Christchurch City Council Akaroa Treated Wastewater Options Consultation (2020)

Submission of
FRIENDS of Banks Peninsula

Submission version V6-3 August 23, 2020

Figure 2 Flow pattern with groundwater drop

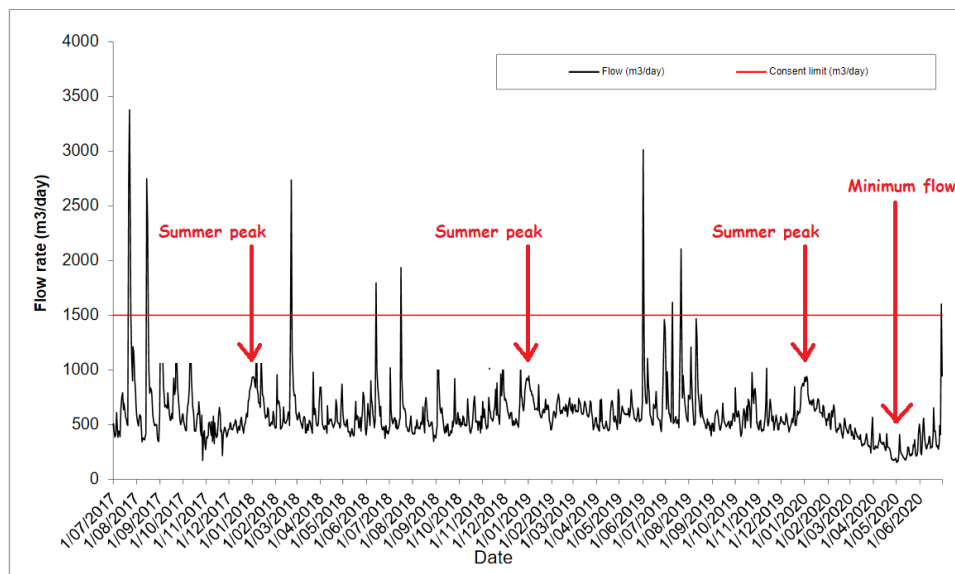
The spikes are infiltration during rainfall events. The summer sewage peaks are below 1000m³ per day and broader. The difference between the base level prior to December 2019 and the minimum point at the end of April 2020 shows the level of ground water infiltration. The decline from December 2019 to April 2020 represents the 2020 summer drought and demonstrates how ground water levels dropped. The level picks up again when it started to rain in May.

As the minimum flow point on the graph above shows, eliminating inflow and infiltration and dealing only with the real sewage would more than halve the wastewater flows and therefore the size of the system needed to deal with them. It would remove the fundamental problem that the wastewater volumes are greatest at the time when water is least needed and most difficult to get rid of.

Figure 3 Akaroa Wastewater Treatment Plant system

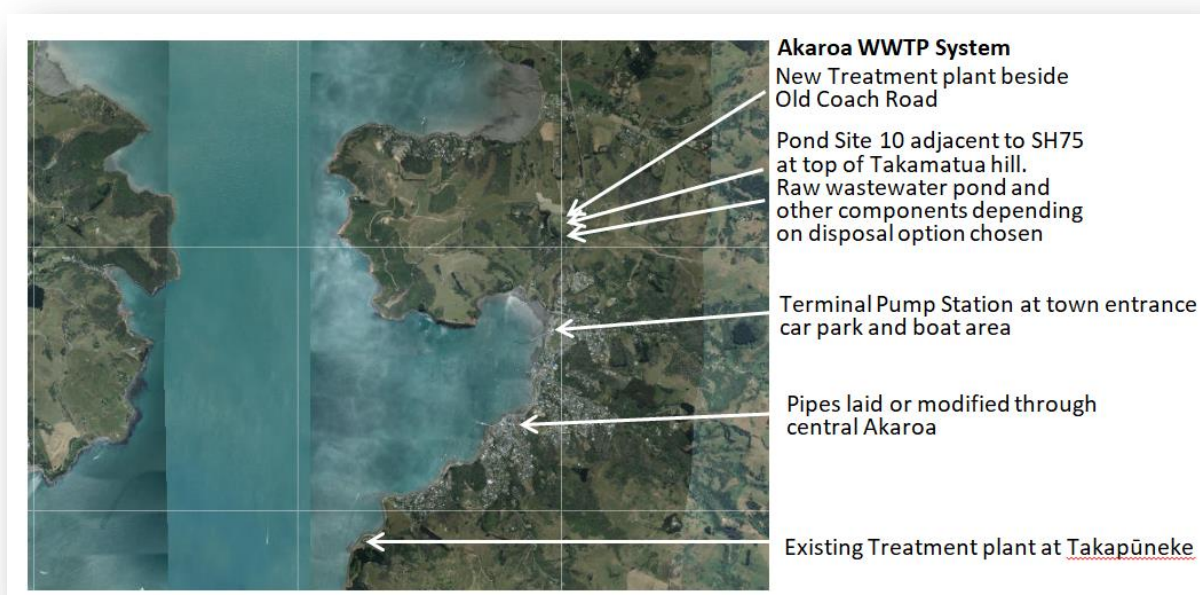
Figure 3 above shows the different components of the new wastewater treatment system consented in 2015. These consents were extended to 2028 as part of the settlement the Council reached with the Environment Court on the withdrawal of its appeal to the 2015 outfall decision.

The plant is physically constrained by its small site and this brings limitations to the treatment options possible and volumes it can handle. A compact ultra-filtration plant is proposed rather than

a traditional plant with oxidation ponds. The plant will have the capacity to process normal flows (up to 14L/s). Sludge will be removed weekly and tankered to Christchurch.

Figure 4 Land projected to be below annual flood level in 2050 in red

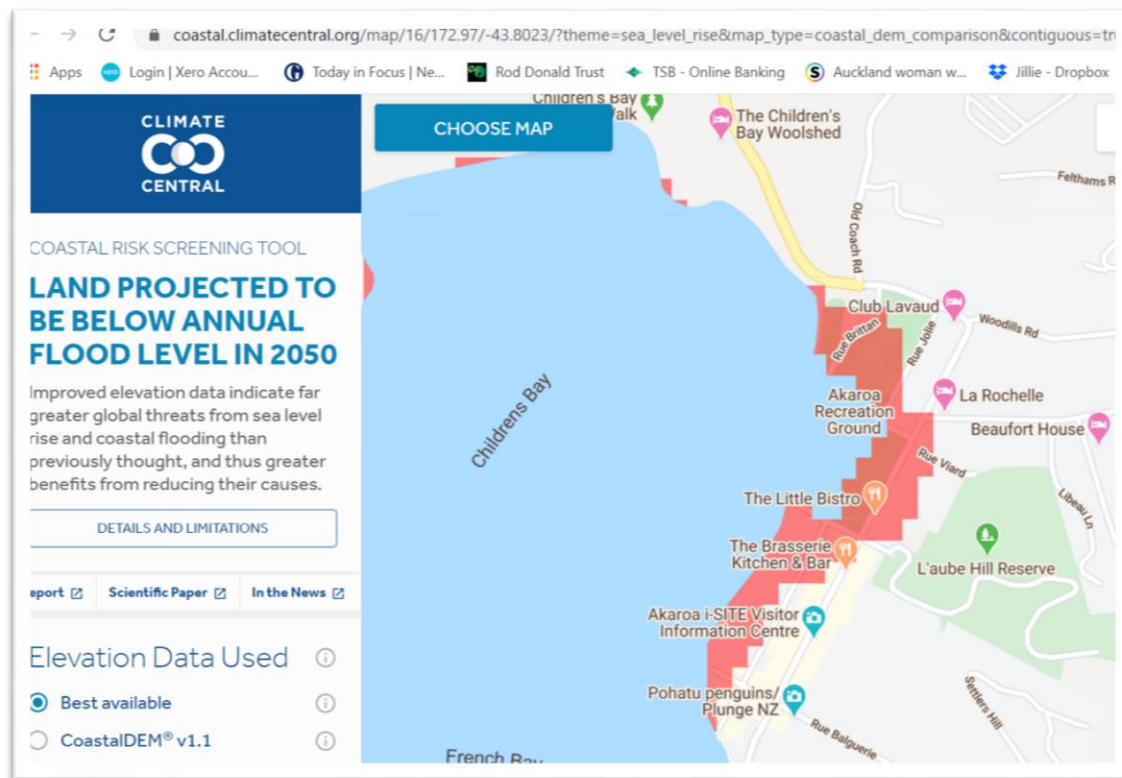
The Terminal Pump Station is located on reclaimed land on top of the former Akaroa refuse disposal site and is only slightly above sea level. **The area is projected to be below the annual flood level in 2050¹³, within the lifetime of the system. We consider this to be a major risk in the design of the new Treatment Plant system.** The vulnerability of capped landfill areas has been highlighted since the consent was issued in 2015 by the failure at Fox River. We strongly suggest that the location of the Terminal Pump Station is reviewed in light of this and a site found further from the coast.

Figure 5 Large footprint of Inner Bays infrastructure in addition to Treatment Plant infrastructure.

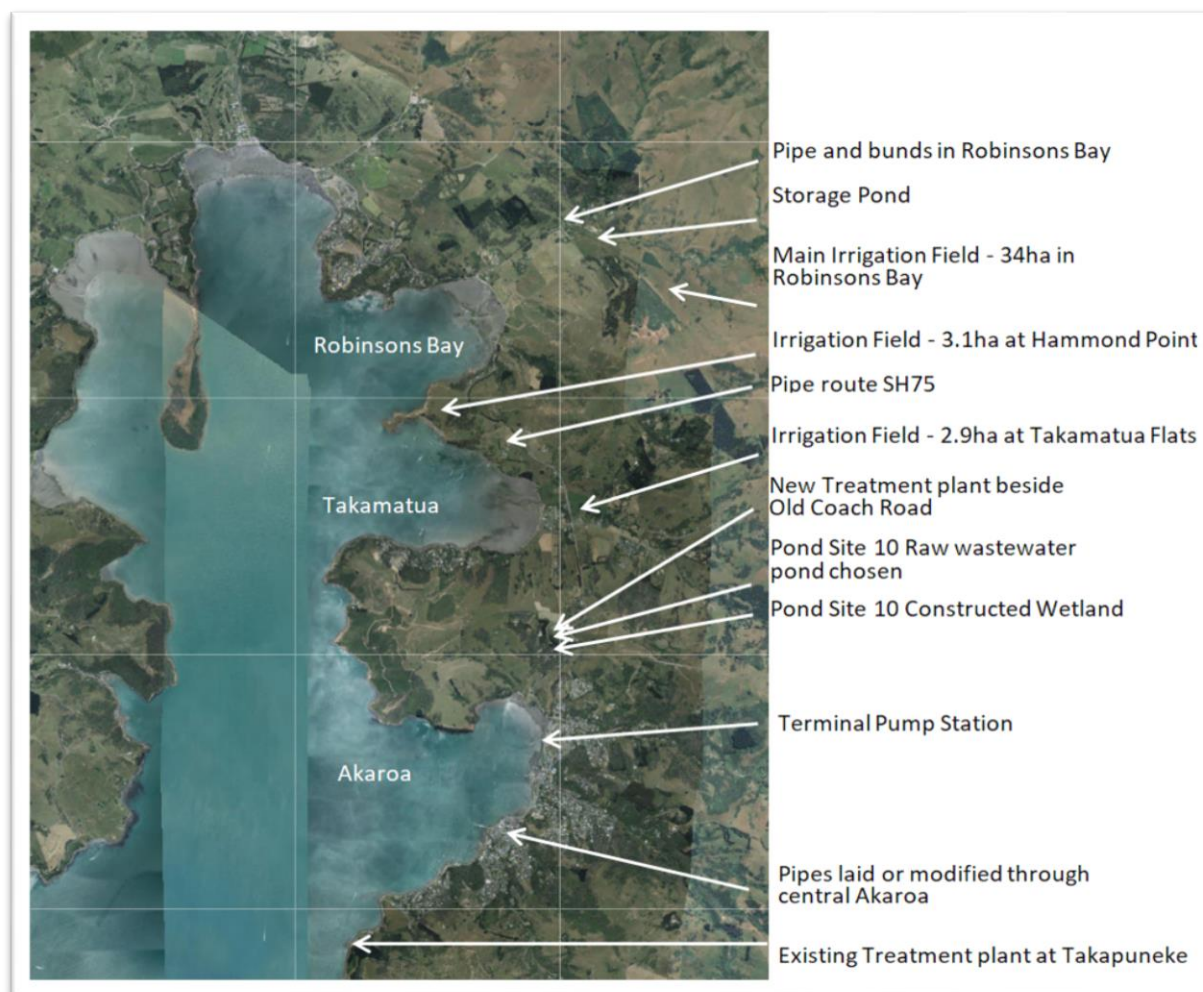
Figure 5 below shows where the Inner Bays option infrastructure would be placed in relation to the new Treatment plant.

This shows the large combined footprint of the new Treatment system with the Inner Bays option. It should be noted that the Duvauchelle scheme will add further wastewater infrastructure into the Inner Bays area on the Duvauchelle golf course and showgrounds should this also become a land based scheme.

Figure 8 Robinsons Bay site

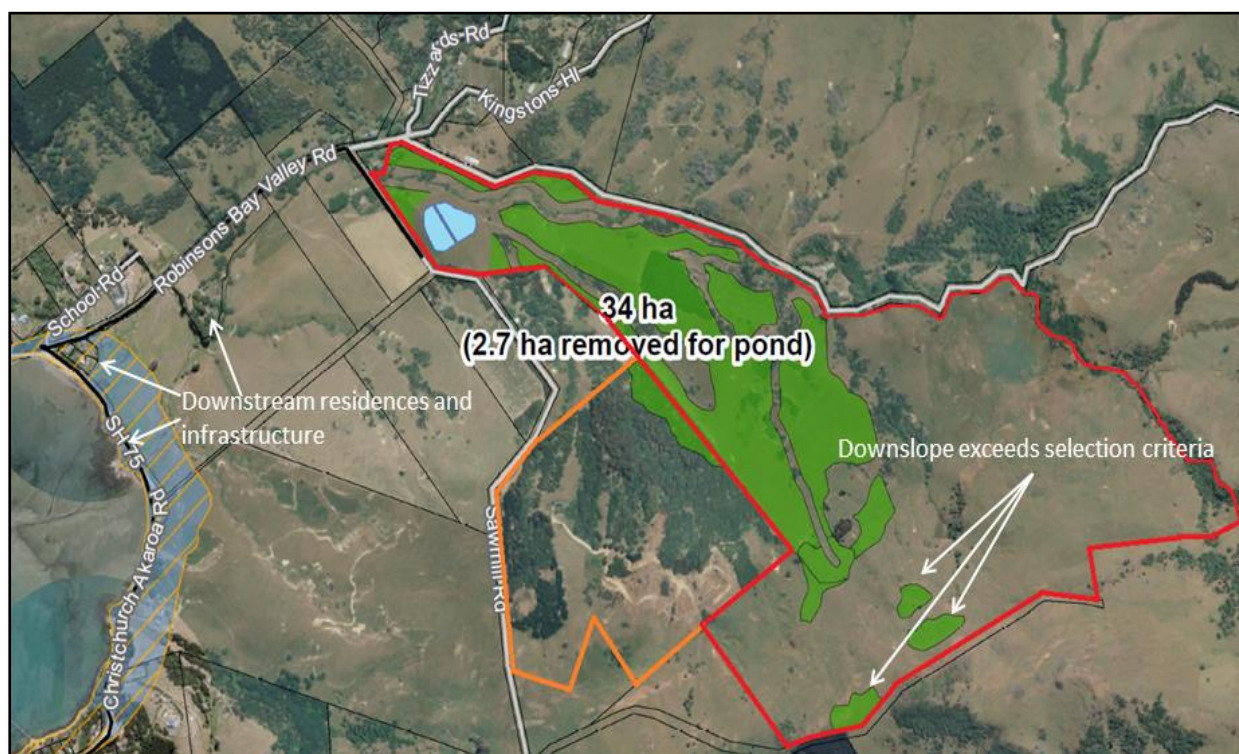
As shown in Figure 8 below, the 34ha is split over two properties. The bulk of it is on 11 Sawmill Road, known as the Thacker property, outlined in red. Additional land is also needed and so a strip of adjacent land on neighbouring 88 Sawmill Road, the Reid property, is included - outlined in orange.

The large storage pond is divided with a central bund as without this Beca considered it presented an unacceptable safety risk. However, there is considerable infrastructure downstream including several houses and a heritage listed building.

Use of the Reid property compromises the water supply of 33 Sawmill Road, the property immediately below.

Figure 9 Storage Pond Thacker Site

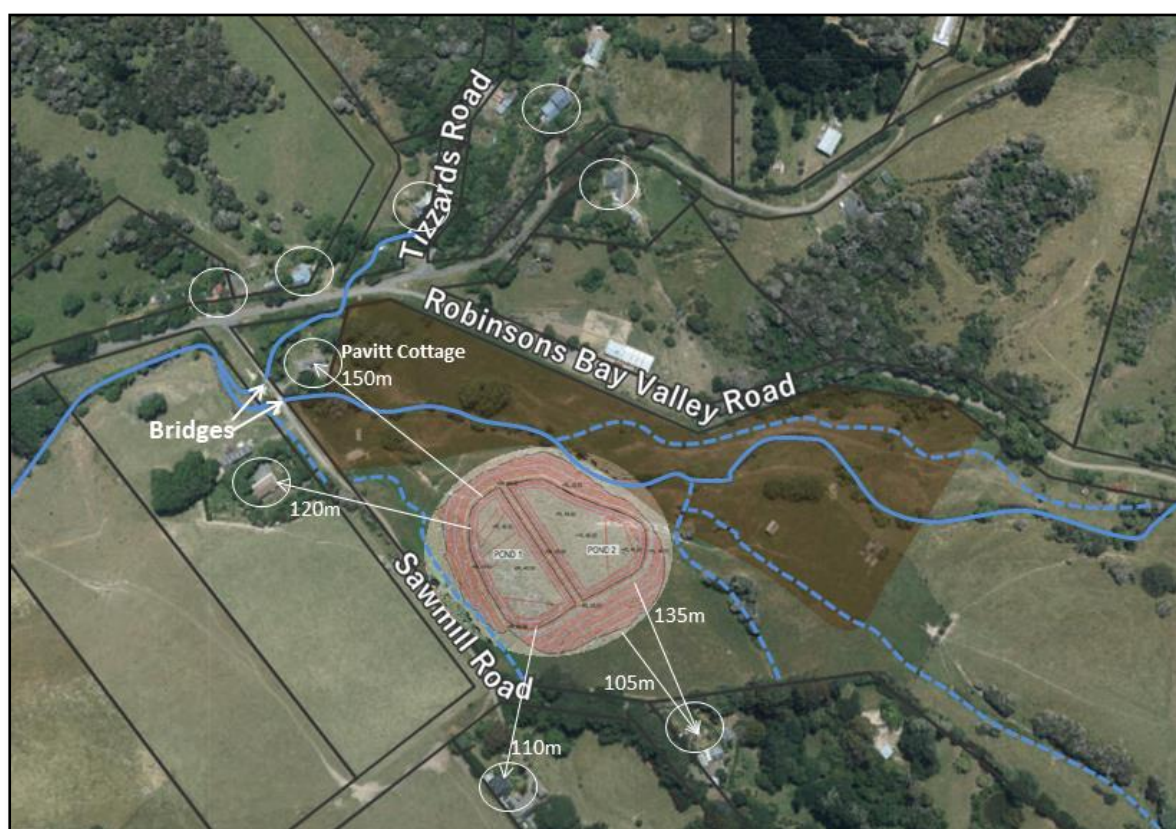
Fitting the 19,000m³ storage pond onto the Thacker Site (11 Sawmill Road) is problematic. See Figure 9 below.

- The site has the sawmill archaeological site area (shaded brown) immediately below it. The house between the Tizzards and Robinsons Valley streams is the associated historic Pavitt cottage. Opposite Robinsons Valley Road is the associated historic Schoolmasters house.

- The storage pond size is reliant on the 20% I&I reduction because the land proposed for irrigation is the *minimum viable area*. If the I&I reductions are not realised, or are negated in the future, the storage and land area would be insufficient⁴¹.

Figure 18 Pompeys Pillar location

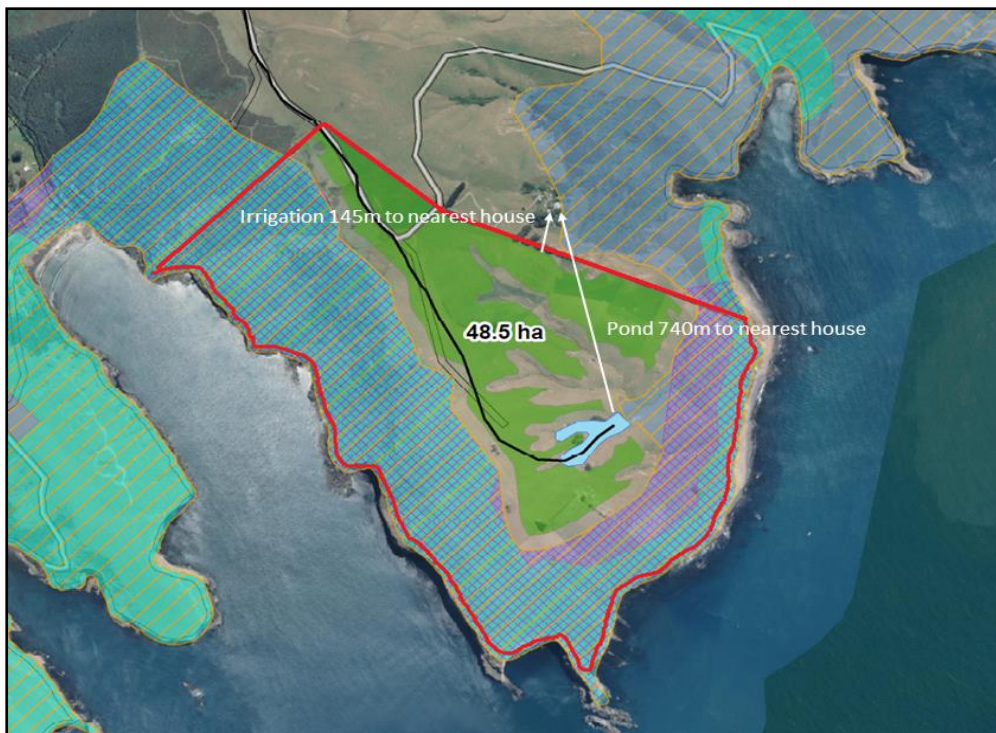
Like Goughs Bay, the proposed site at Pompeys Pillar is a remote farm with few near neighbours, and with low visual impact on the landscape. The proposed irrigation area is on a pastoral headland, with no streams or areas of ecological sensitivity. The impact on neighbours and the local environment would be minimal, but the scheme again represents a lost opportunity because Akaroa's water would be pumped out of the catchment and used to establish a small area of planted native bush, rather than re-used in Akaroa where it is needed.

The key difference is that, unlike Goughs Bay which was recently purchased by its current owner, the Pompeys Pillar farm has been in the same family for six generations and has strong heritage value and ancestral connections to its owners. The area identified is at the heart of the farm and is financially critical to the farm. Given that this option would likely require compulsory purchase, the injustice brought upon the family would be severe. We consider such a proposal to be a violation of natural justice.

We also agree with the concerns expressed by the landowner and Wildside community that establishing native trees on the coastal and windy headland would be very difficult and they could well take many years to establish and be more stunted in form, leading to less canopy intercept.

Figure 19 Changes in cost over time

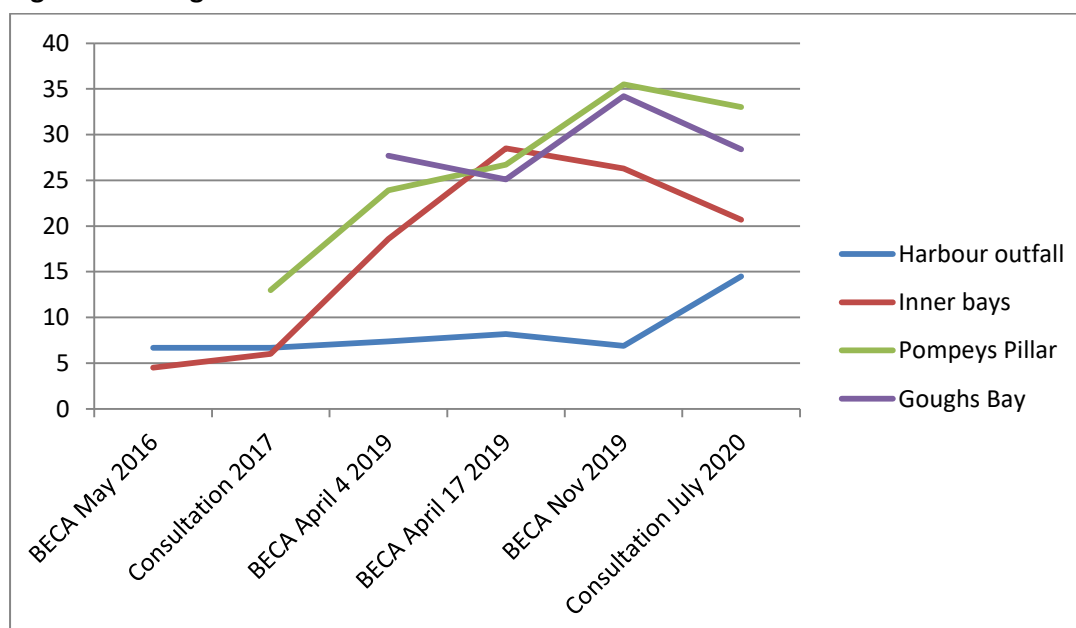
During the past four years of investigation, the costs of the various disposal options have not only risen dramatically, they have also varied significantly relative to each other. The chart below shows the varying cost of each option, presented at different times to the Working Party.
